City Lights Prom/Terrys Bridal

METRO LOUISVILLE
APPROVED DISTRICT DEVELOPMENT PLAN
DOCKET NO. 17ZONE1028
APPROVAL DATE
EXPIRATION DATE
SIGNATURE OF PLANNING COMMISSION
Laura L Moore
PLANNING COMMISSION

17 ZONE 1028

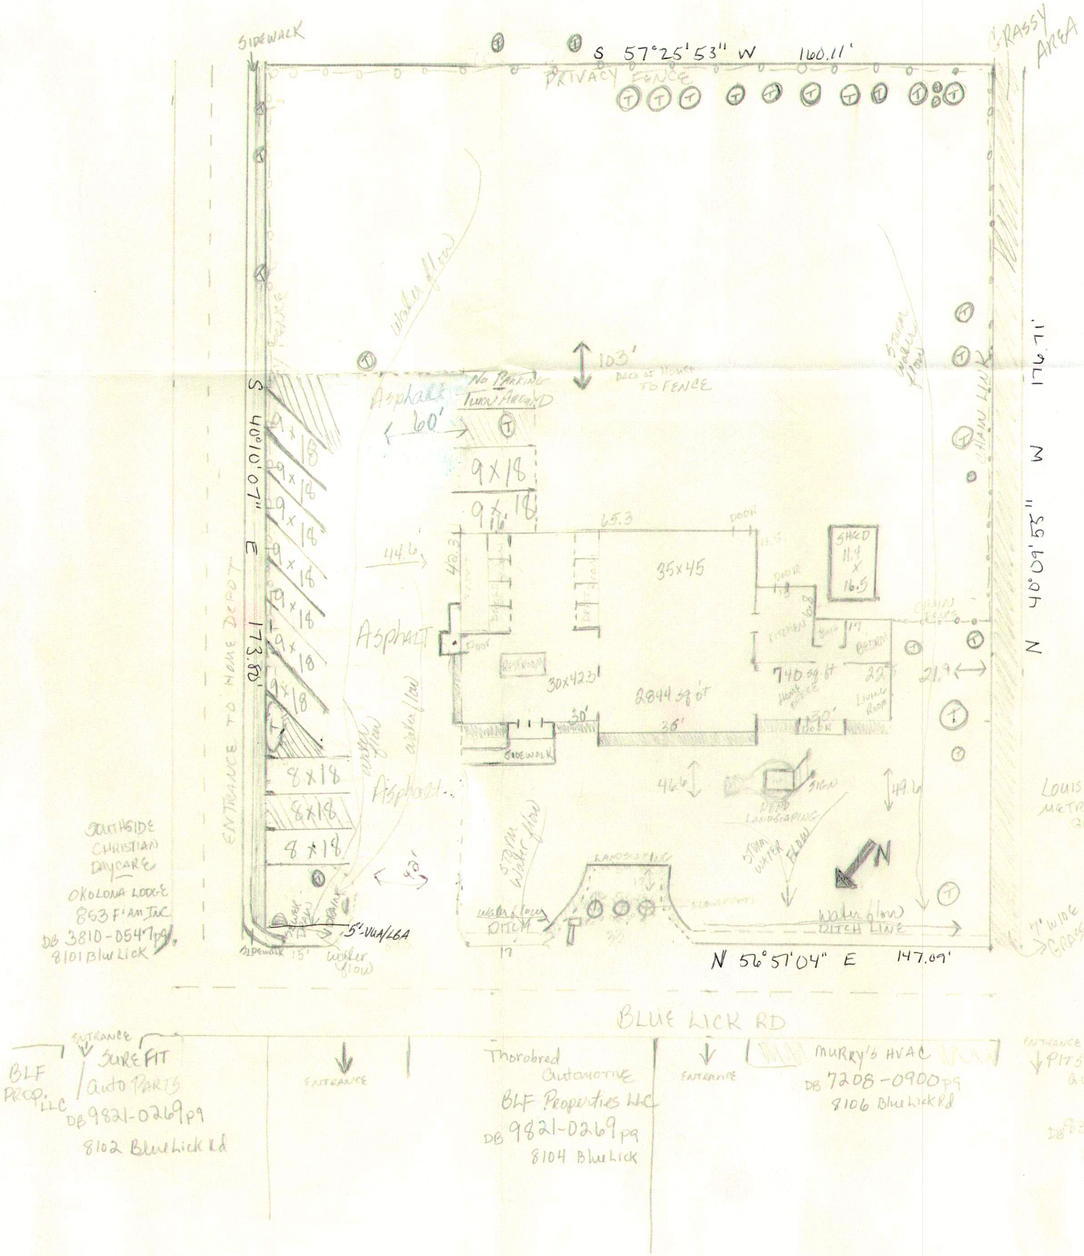
Code Violation Text: "All developments shall provide sidewalks in the abutting right-of-way to serve the development site (same side of street). Sidewalks shall be provided along all road frontages in accordance with Section 5.2.6. The minimum sidewalk width shall be four (4) feet for local level roads, and five (5) feet for collector and arterial level roadways. The Director of Works may require greater width or, for infill sidewalks connecting existing sidewalks of lesser width, may approve a sidewalk of lesser width upon finding that divergence from the five (5) foot standard is consistent with public safety. If sidewalks are present in the public right of way fronting adjacent lots, the location and alignment of the new sidewalk shall connect directly with the existing network. 1. Sidewalks shall be designed in such a manner that a walkway at least 4 feet wide or other dimension as approved by the Director of Works is left unobstructed. 2. Where the sidewalk along a public street is interrupted by a curb cut, the walkway across the driveway shall be delineated to enhance pedestrian safety. The walkway may be delineated by striping or by use of contrasting pavement materials that meet ADA standards."

Notes:
Construction plans, bond, and KTC permit are required by Metro Public Works prior to construction approval and issuance of MPW encroachment permit.

Notes: KYTC approval required prior to MSD construction plan approval.
Site is subject to regional facility fee X 1.5
Verification of the downstream storm water system is required prior to MSD construction plan approval.
Erosion Prevention and Sediment Control Note:
